RENESAS TECHNICAL UPDATE

Product Category	MPU/MCU		Document No.	TN-78K-A010A/E	Rev.	1.00
Title	Correction for Incorrect Description Notice 78K0R/Lx3 Descriptions in the User's Manual: Hardware Rev. 5.01 Changed		Information Category	Technical Notification		
Applicable Product	78K0R/Lx3 Group	Lot No.	Reference Document	78K0R/Lx3 User's Manual: Hardware Rev. 5.01 (R01UH0004EJ0501)		
		All lots

This document describes misstatements found in the 78K0R/Lx3 User's Manual: Hardware Rev. 5.01 (R01UH0004EJ0501)

Figure 16-1. Block Diagram of LCD Controller/Driver (Page 666)

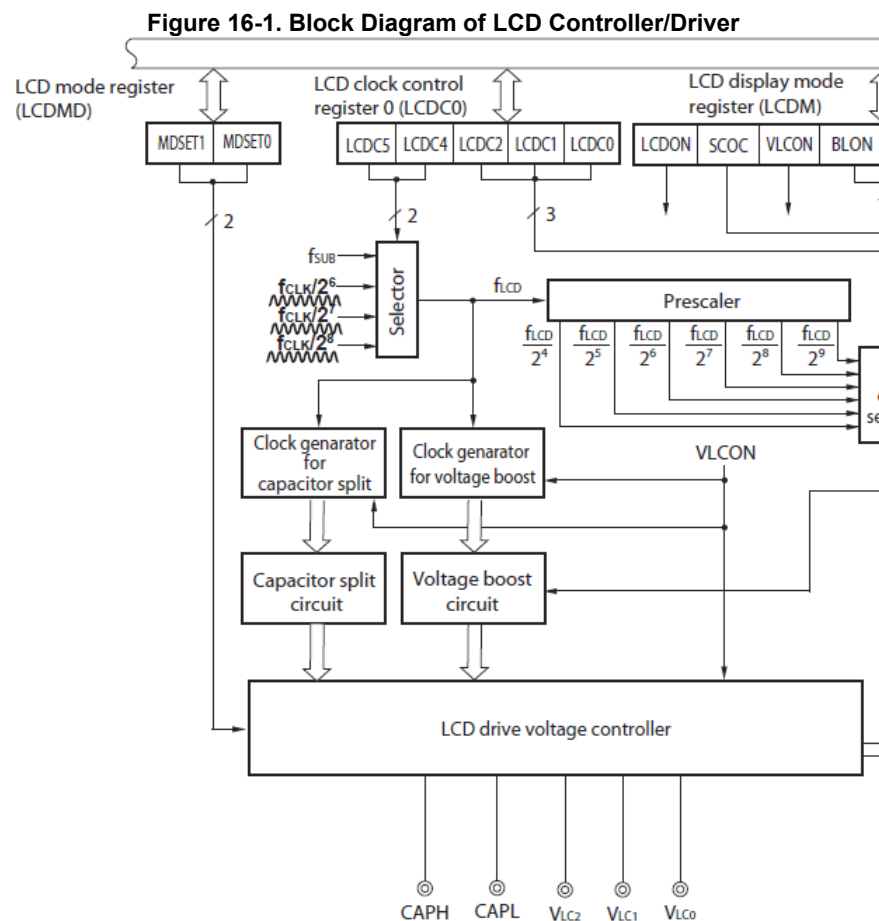
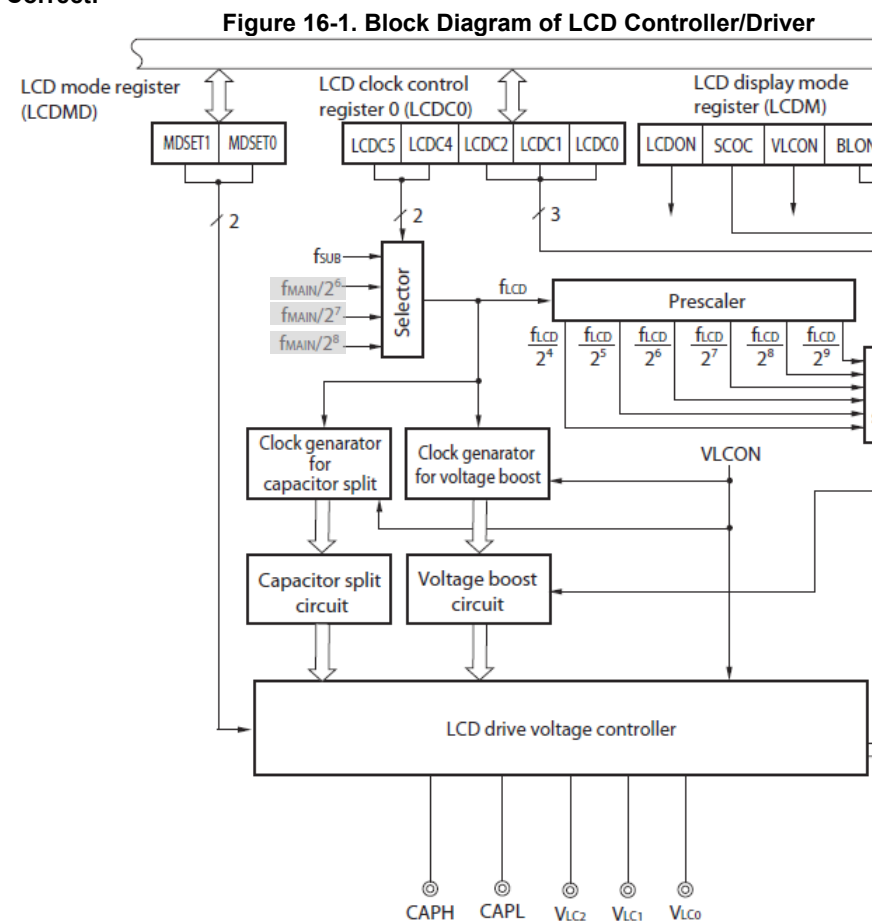
1. 16.2 Configuration of LCD Controller/Driver

Incorrect:

Correct:
